Council of the Isles of Scilly Delegated Planning Report Householder application

Application Number: P/25/075/HH

Site Address: 7 Buzza Street
Hugh Town
St Mary's
Isles Of Scilly
TR21 0HX

Proposal: To demolish and replace the existing ground floor extension, the addition of a first floor dormer and roof terrace, and internal alterations

Existing (L) and Proposed Front Elevation (the proposal includes render removal)

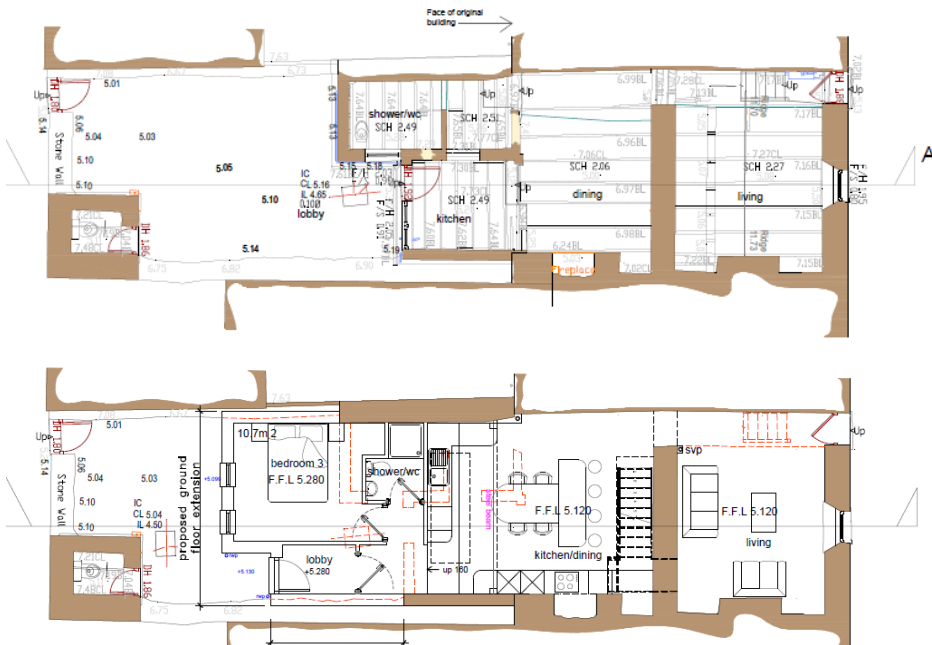
Given the nature of surrounding approved extensions to the rear of this terrace, which includes a range of styles, it is difficult to conclude that the proposal is out of character in this context. Although the rear of the application site backs on to a through-road, it remains the rear of the terrace. For example, No. 8 Buzza Street has a larger flat-roof dormer and a two-storey rear extension, while No. 6 is notably taller than Nos. 7, 8, and 9. In my view there is little uniformity to the rear elevations that would be harmed by the proposed extension.

The use of a slate roof on the dormer and rendered walls to match the existing property ensures consistency with the terrace. While the cowed Juliette balcony detail is not a common feature, it is not considered to cause obvious harm. It has been introduced specifically to protect neighbouring privacy and amenity, and this alone does not amount to significant harm to the character of the property or the conservation area.

Existing (top) and Proposed Ground Floor plan

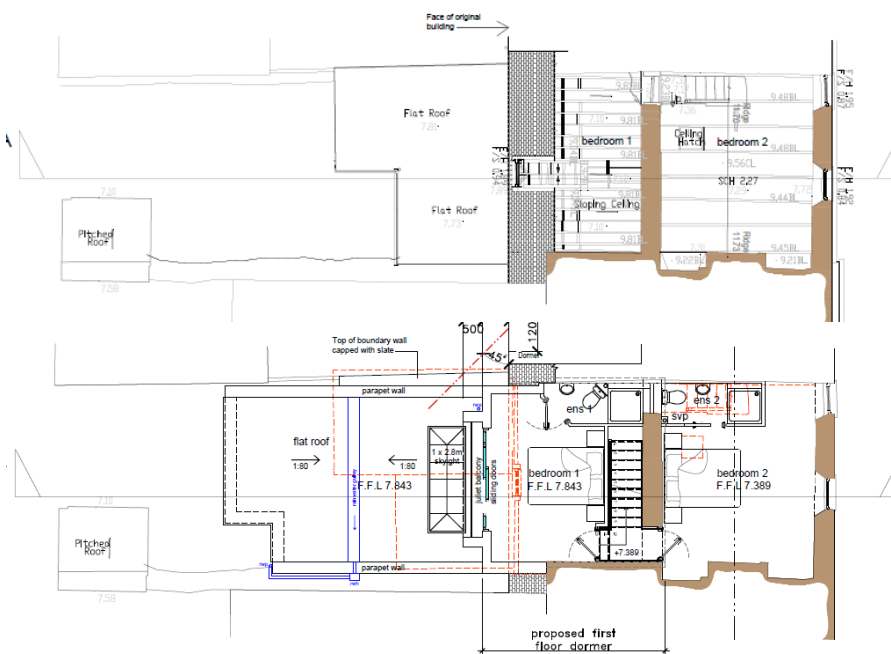
The proposal seeks to remove the small dormer and construct a larger dormer extension to span to a width of around 4.5m, which is almost the full width of the dwelling. This will project 600mm further into the yard than the neighbouring property at No. 8. This change has some potential to reduce light levels to side-facing and rear-facing windows at No. 8.

The proposed reconstruction of the ground floor extensions, will see this shifted in from the boundary with number 8. The replacement extension, although larger, will be single storey and retain flat roofs. This is not considered to result in significant amenity impacts. The original submission included a roof terrace; which has now been removed due to concerns over privacy and amenity issues.

The amended plans have been subject to re-consultation. The amended plans remove the roof terrace and instead propose a Juliette balcony with a cowled canopy. The canopy is intended to protect the privacy of No. 8 by limiting views from the balcony towards its side-facing windows.

Figure 3 Existing window arrangements at first floor between number 6 (Blue) and number 7 (RED) (application site)

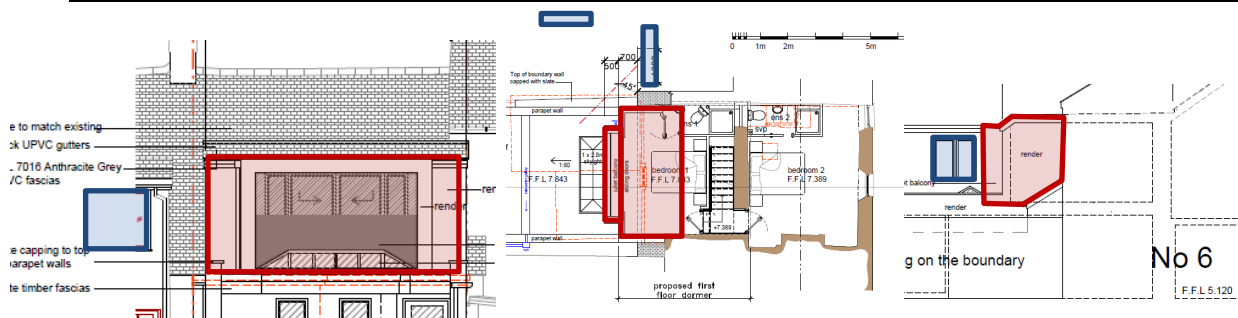
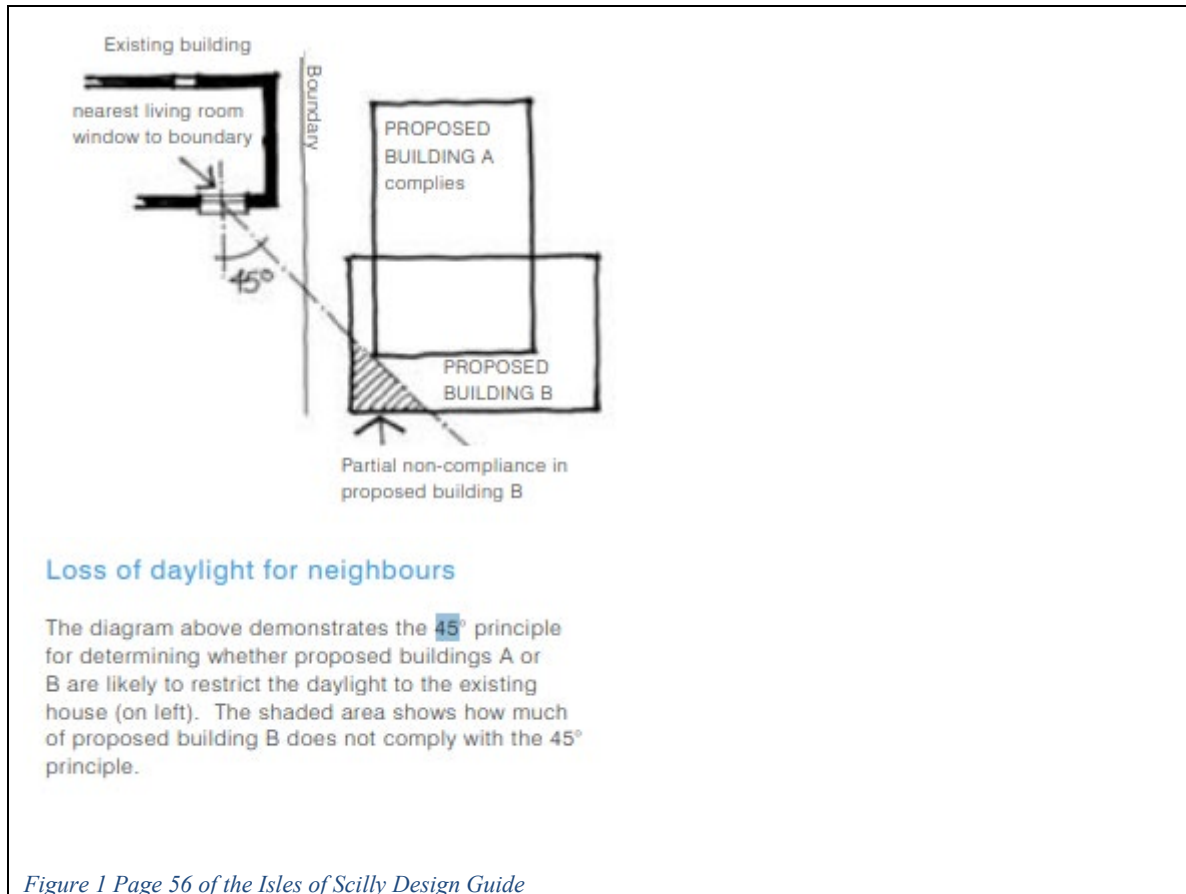
In order to demonstrate the impact on the neighbouring property the plans show a 45-degree line drawn from the rear upper floor window of number 8. This is advocated in the Design Guide as a means to demonstrate an acceptable impact upon a neighbouring property. This does demonstrate that although close the projecting cowled dormer does not restrict outlook for the neighbouring property. Although it is likely to have reduced light levels, its general outlook would be protected.

Response to this representation: This is a material planning consideration. The enlarged dormer will project further than the neighbour's dormer and may reduce light to side-facing and rear-facing windows at No. 8. However, the degree of impact appears modest on the basis of complying with the 45-degree principle advocated for in the local design guide. It is not considered to be justified as a reason for refusal on its own.
